Access Compliance Report

Public Rights-of-Way (Curb Ramps)

Intersection ID: N/A	Main Street: PROVIDENCE_RD	Cross Street: N/A	Location: N
ADA ID: 54F72727C8C1	Ramp Type: Directional1	Initial Pass/Fail: Fail	Overall Compliance: No
Severity Score: 1.25			
Codes/Mitigation Info/Possible Solution		Field Measurements/Component Compliance

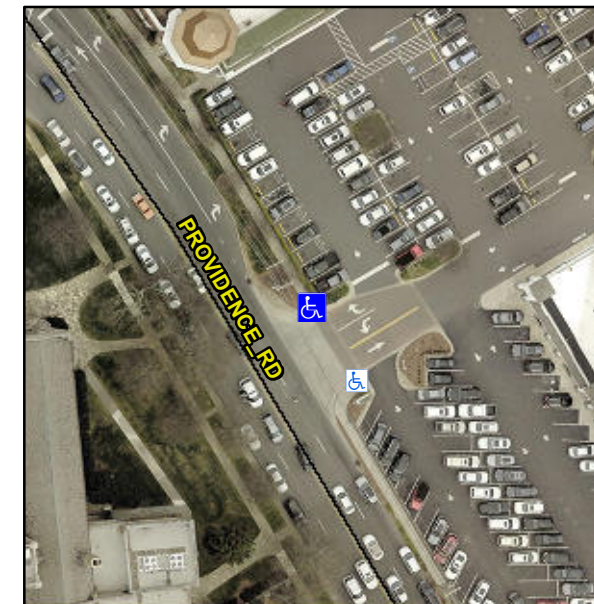
XWALK PAVERS

R304.5.3

Compliance	Description	Data	Compliance	Description	Data
N/A	Ramp Length (in)	90.0	N/A	Grade Break?	N/A
Yes	Ramp Width (in)	72.0	N/A	Grade Break Slope (%)	0.0
Yes	Ramp Slope (%)	1.5	N/A	Grade Break XSlope (%)	0.0
No	Ramp XSlope (%)	2.3			
N/A	Flare Type LT	N/A	N/A	Flare Type RT	N/A
N/A	Flare Slope LT (%)	N/A	N/A	Flare Slope RT (%)	0.0
N/A	Flare Traversable LT?	N/A	N/A	Flare Traversable RT?	N/A
N/A	Landing Length (in)	0.0	N/A	DWS Provided?	N/A
N/A	Landing Width (in)	0.0	N/A	DWS Contrast?	N/A
N/A	Landing Slope (%)	0.0	N/A	DWS Length (in)	N/A
N/A	Landing X Slope (%)	0.0	N/A	DWS Full Width?	N/A
N/A	Landing Curb? (Y/N)	N/A	N/A	DWS Offset LT (in)	N/A
N/A	Shared Landing?	N/A	N/A	DWS Offset RT (in)	N/A
N/A	Gutter Ponding?	0.0	N/A	Gutter Slope (%)	N/A
N/A	Gutter Lip Ht (in)	0.0	N/A	Gutter X Slope (%)	N/A
N/A	Painted X Walk1?	Yes		Road Slope (%)	3.7
	X Walk 1 Direction	To SE		Road X Slope (%)	2.1
	X Walk 1 Width (in)	72.0		Clear Space?	N/A

Remove & Replace Entire Ramp.
